Eagle Ranch Association
Regular Meeting
Design Review Board

MINUTES OF A MEETING OF
THE DESIGN REVIEW BOARD OF
EAGLE RANCH ASSOCIATION

Design Review Memorandum

Project Number: 25-00-64
Owner Name: Jill and Collier Pennington
Architect: Brennen Fitzgerald – Scott Turnipseed AIA
Address: 1880 E Haystacker Dr
Legal: EAGLE RANCH FILING 25 Lot: 64
Preliminary DRB Meeting Date: April 18, 2024

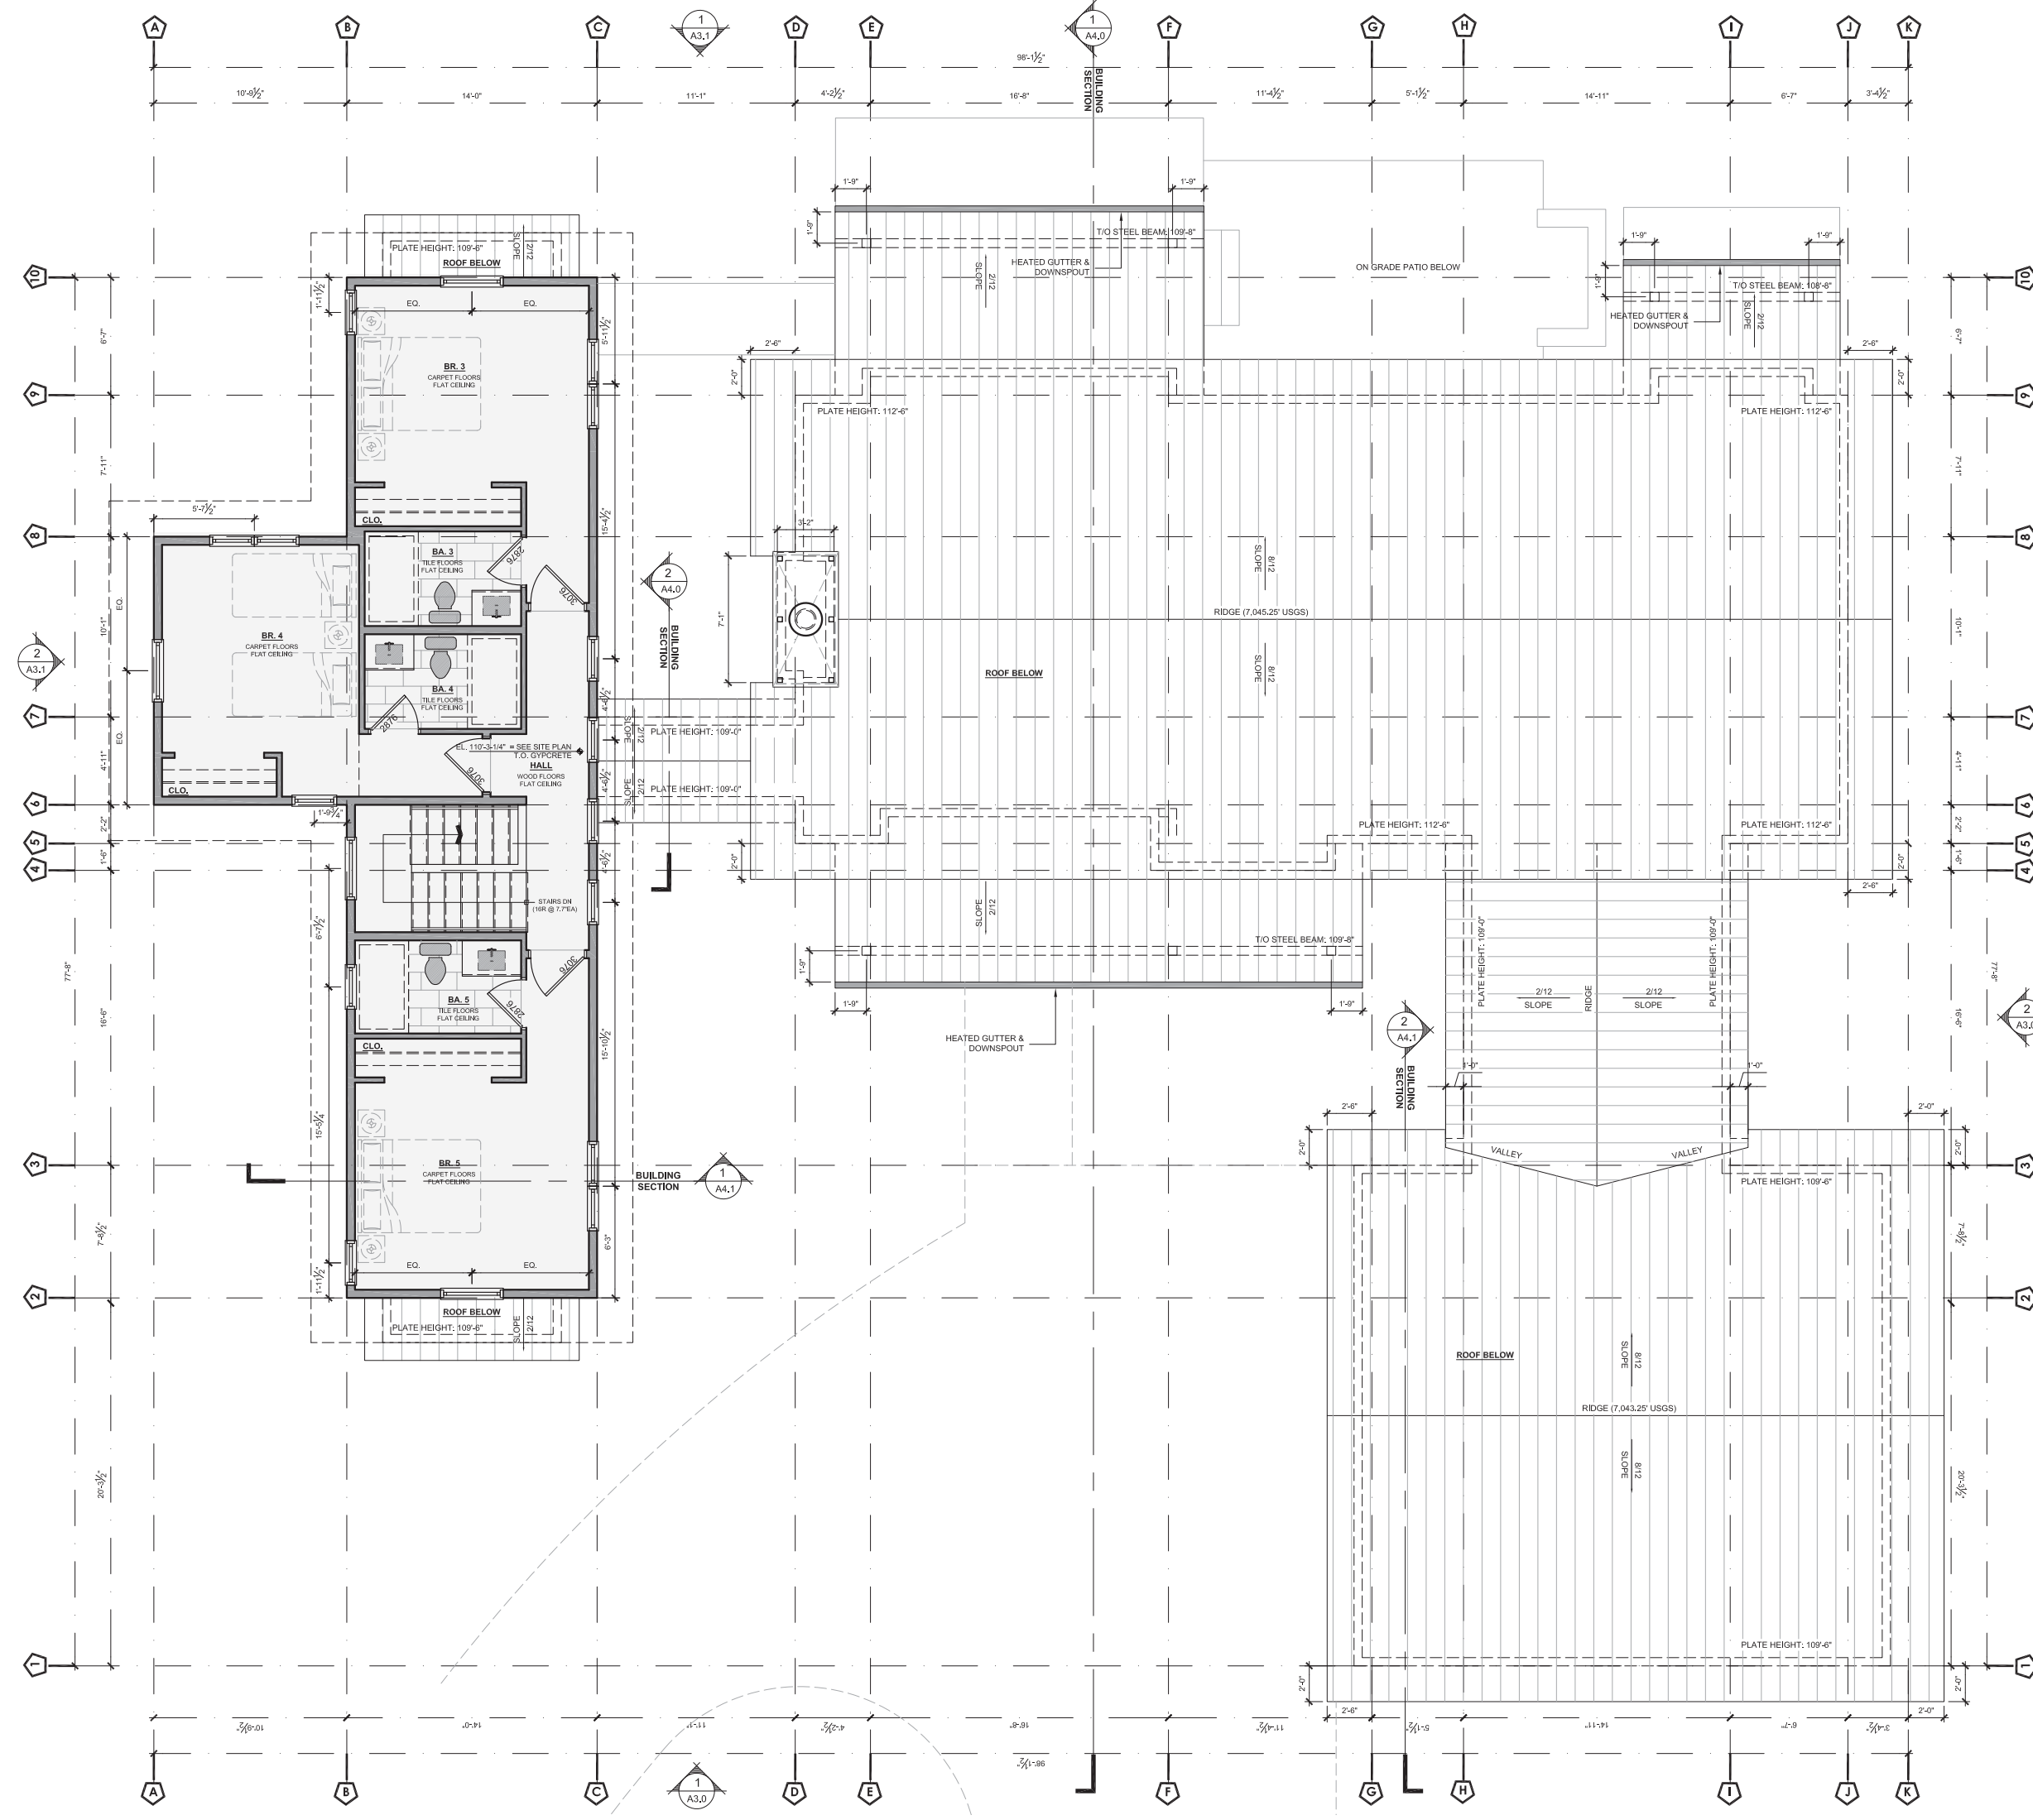
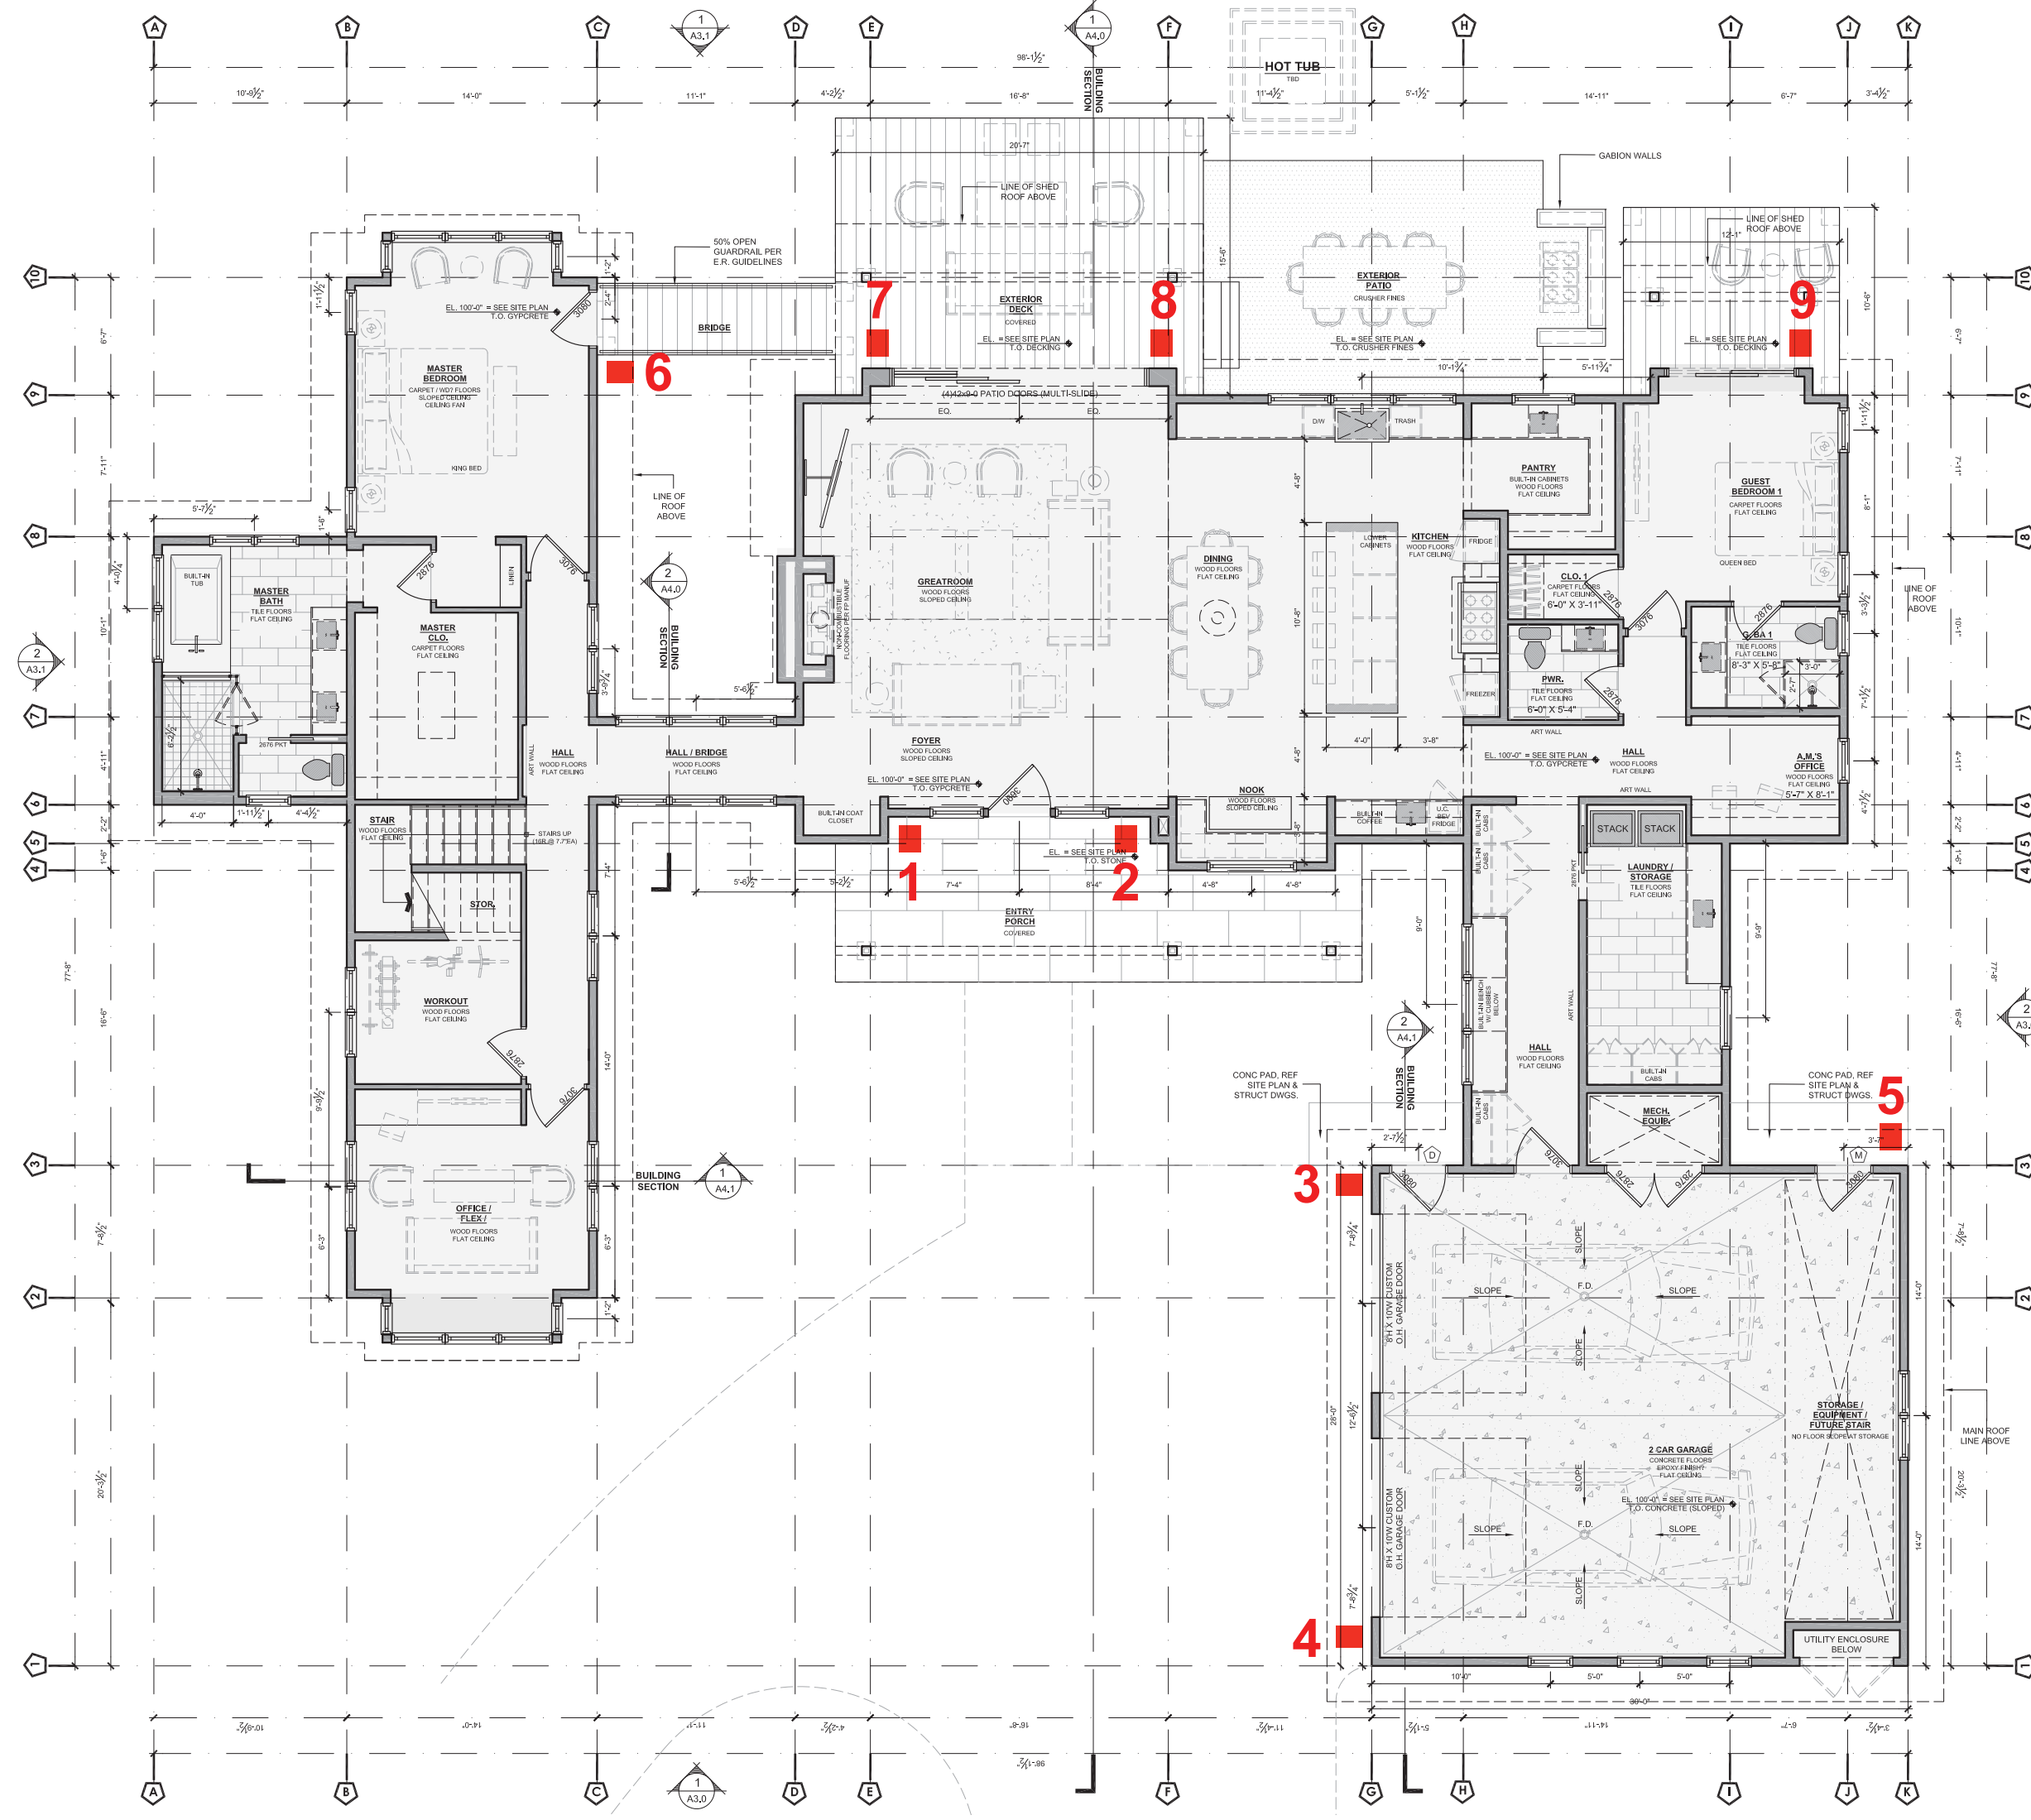
Provide cost estimate for final landscaping and irrigation and anticipated landscape completion date for Technical Review

1 ROOF PLAN
A2.2 3/16" = 1'-0"

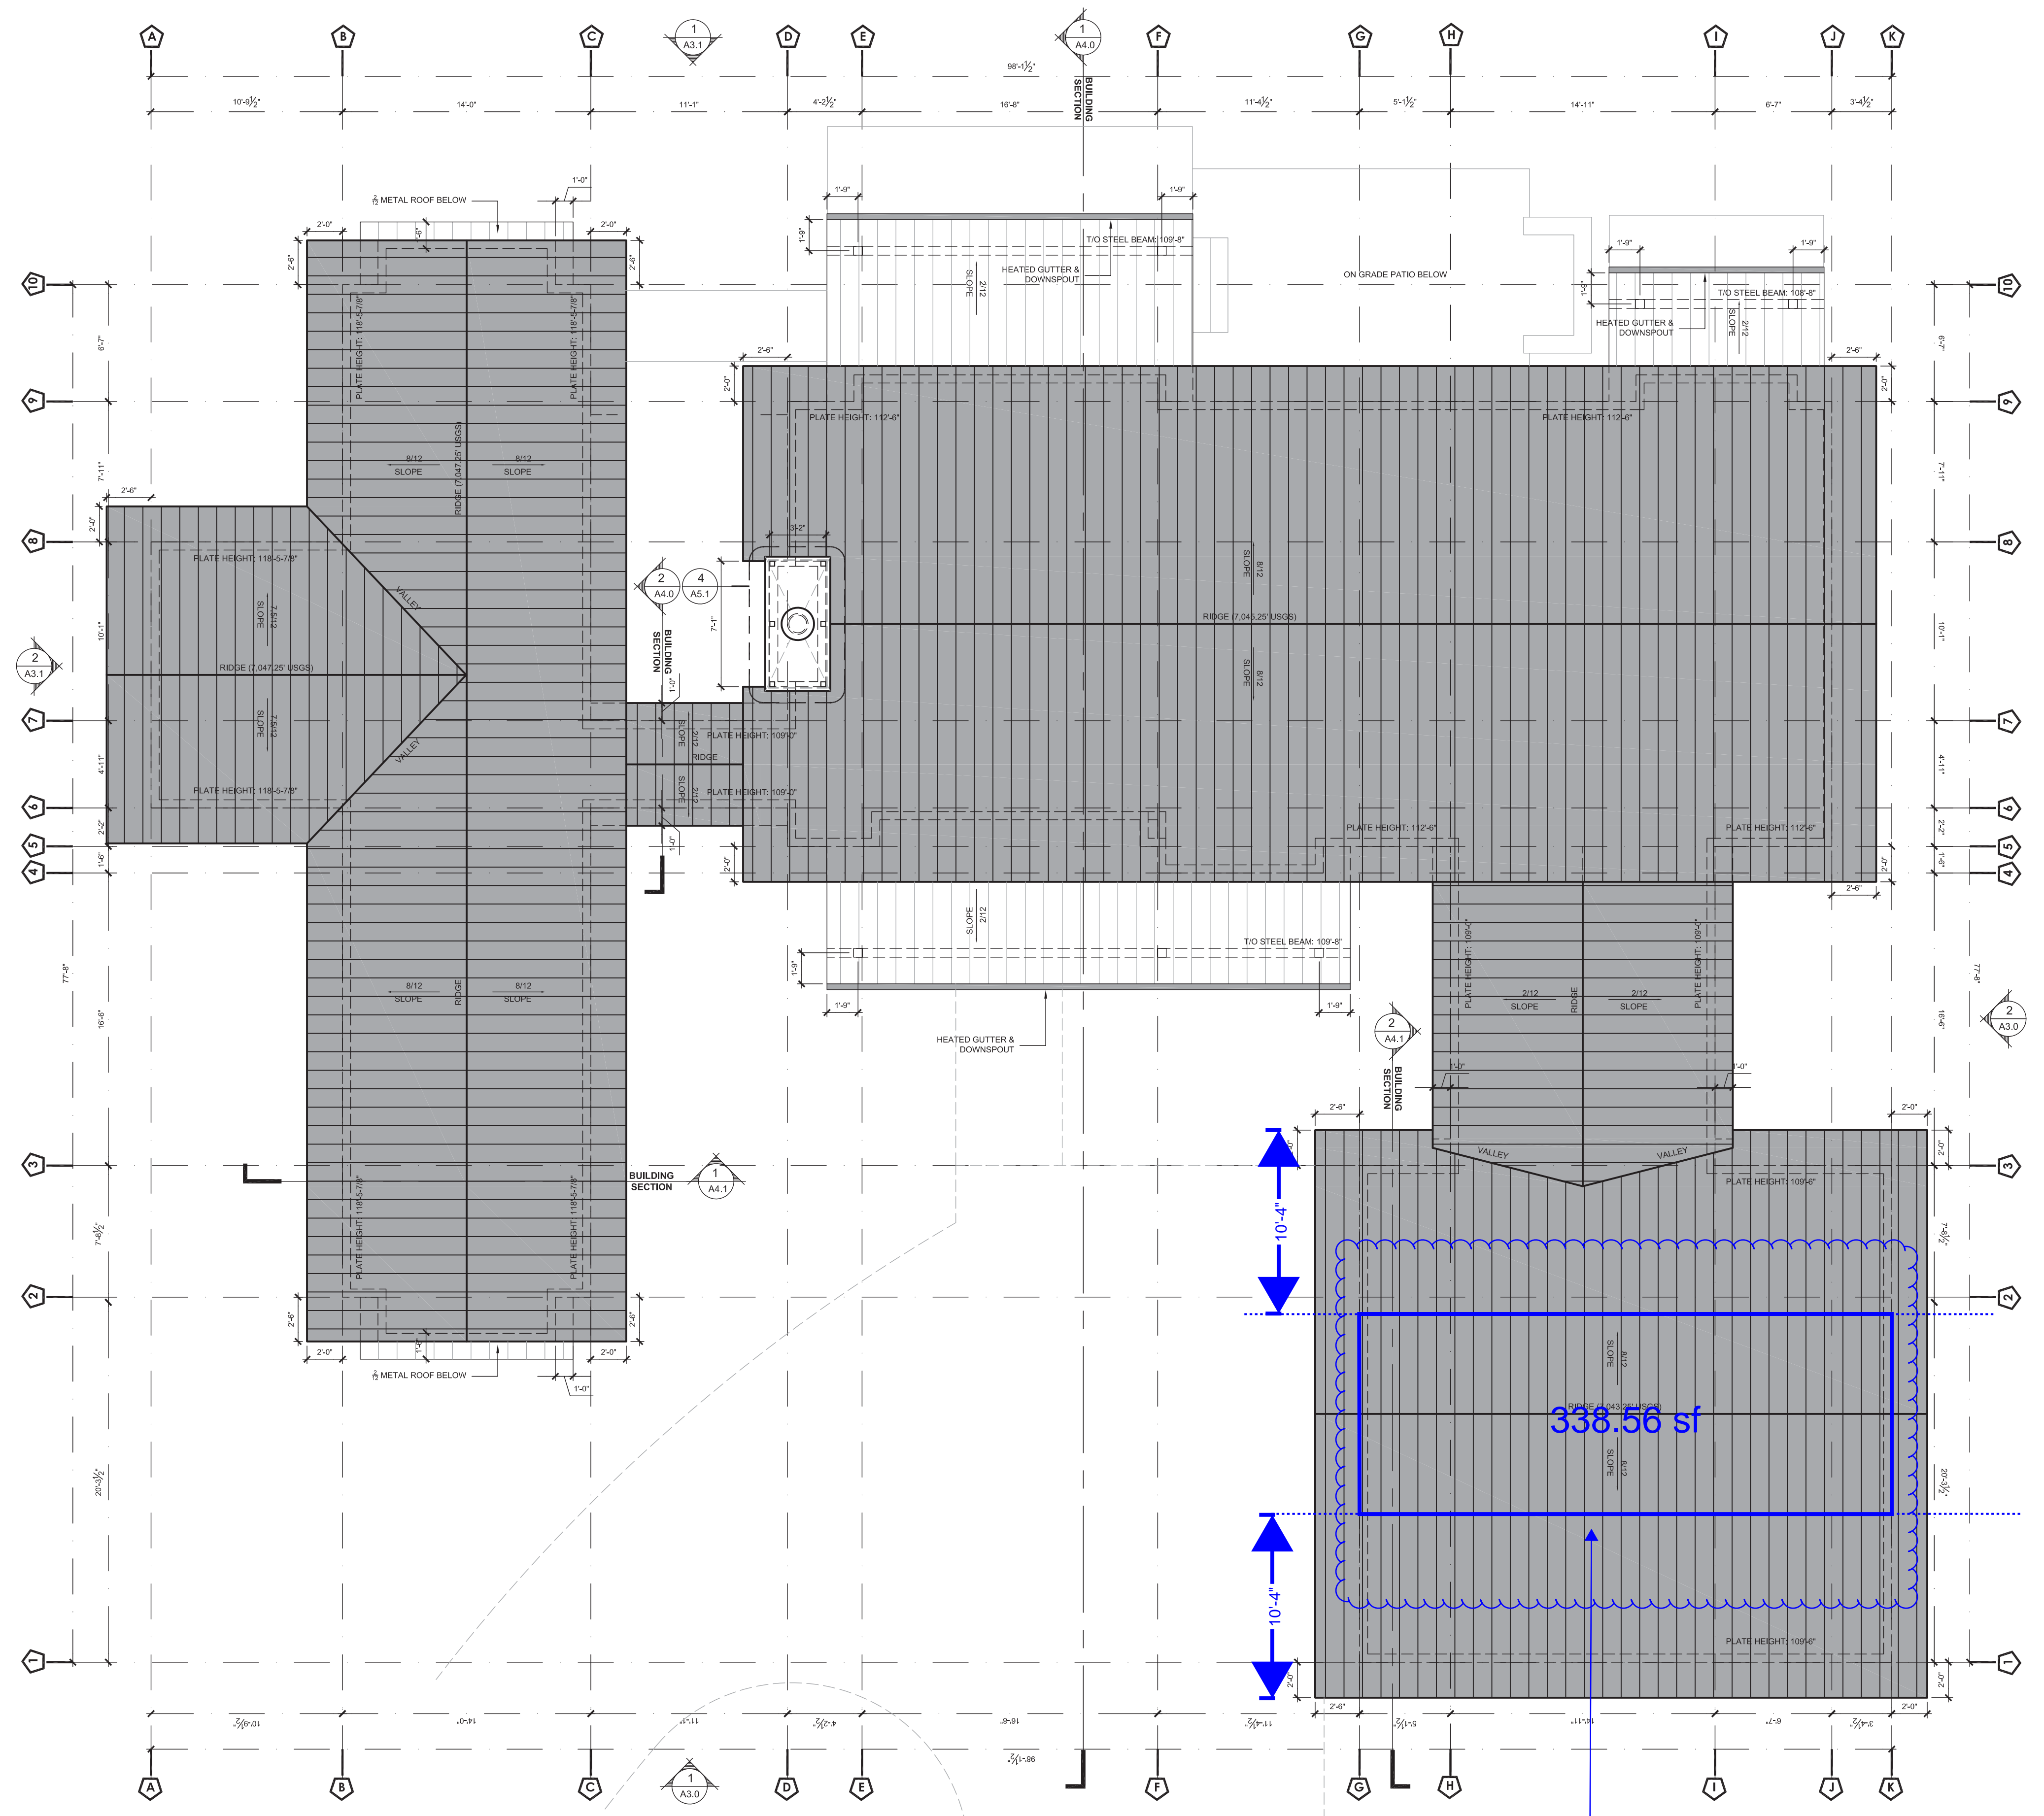
Area above garage where ceiling height exceeds 5 feet must be indicated on plan(s) and included in floor area calculations.
